SB, Blade guards - new setup, WS440 HF, WS460, WS462, WS463, WS482 HF, 2015-10

Figure 1: Blade guard parts in the new setup

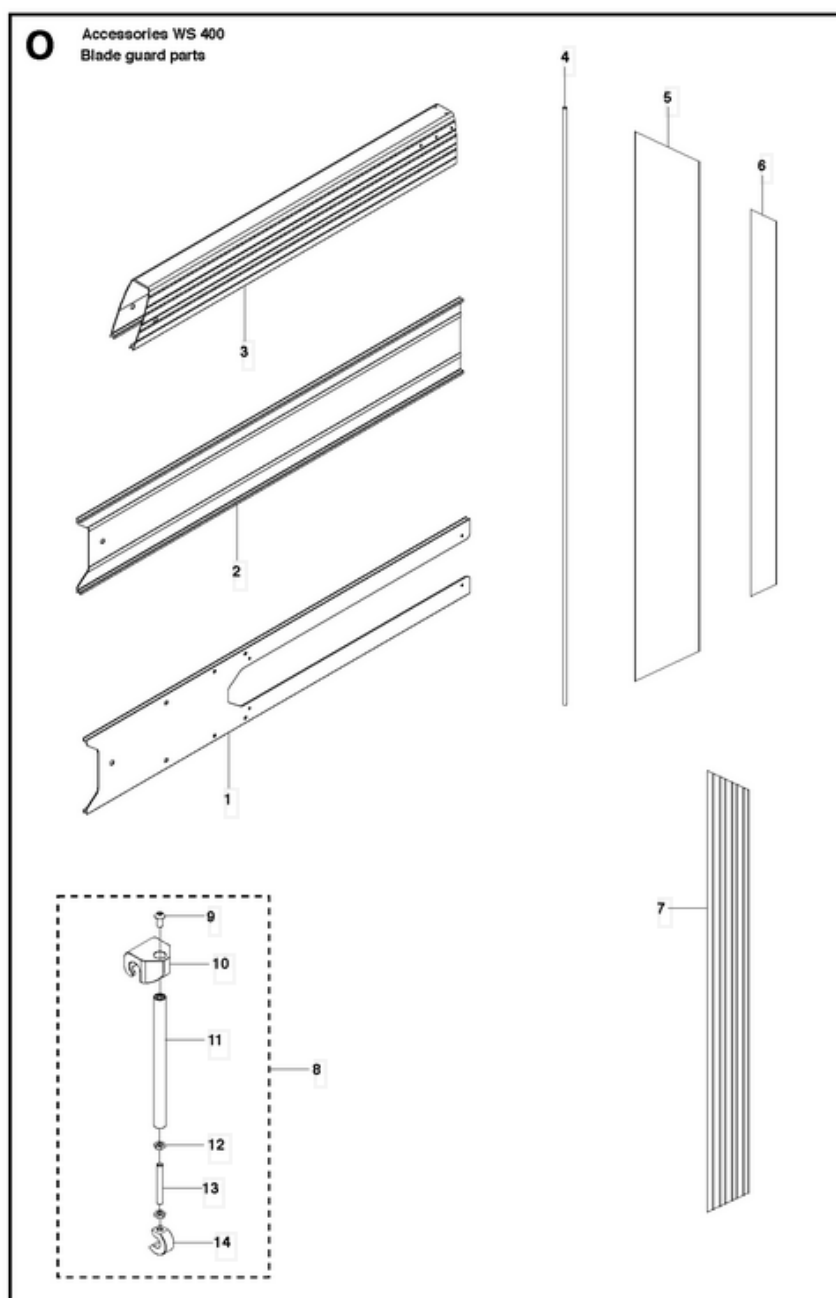
A new setup for the wall saw accessories has been created to make it possible to replace a panel piece on a blade guard instead of a whole section. The new setup consists of universal plates, which easily can be adjusted locally.

When only a panel piece of a blade guard needs to be replaced, order a universal panel piece and adjust it locally.

Figure 7: Measure for Baffle Plate 576 14 15-31

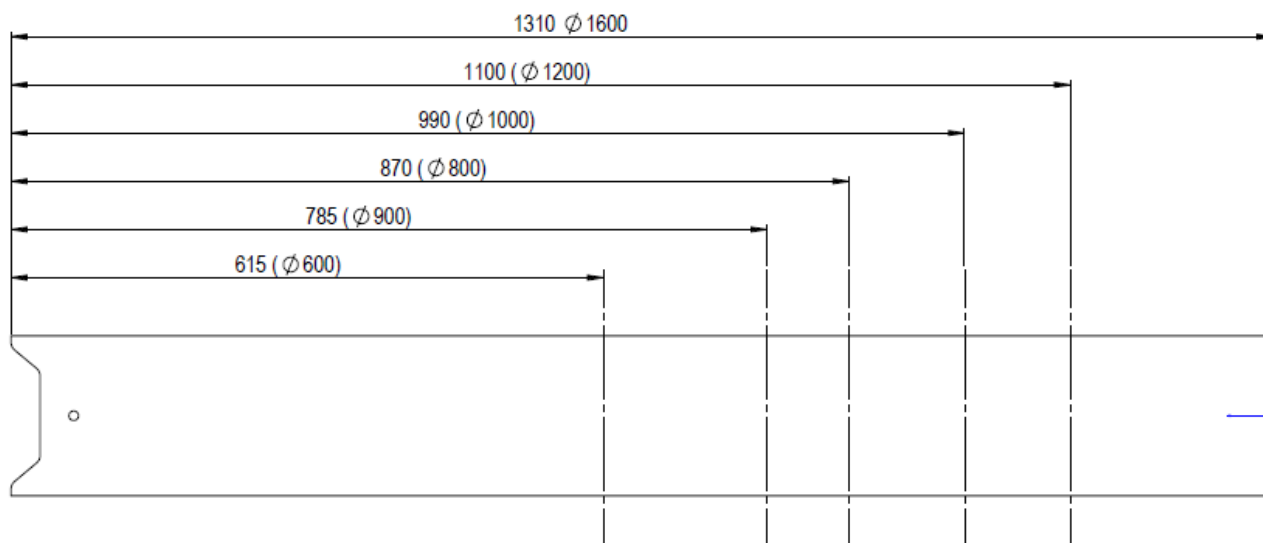
The universal panel pieces can easily be cut to the wanted size with a hacksaw. The easiest way to create the necessary holes is by using the old panel piece as a guide. Below are some measures, which can be of help. To clarify; when it says 1310 Ø 1600, it means that the length should be 1310mm for a 1600 blade guard.
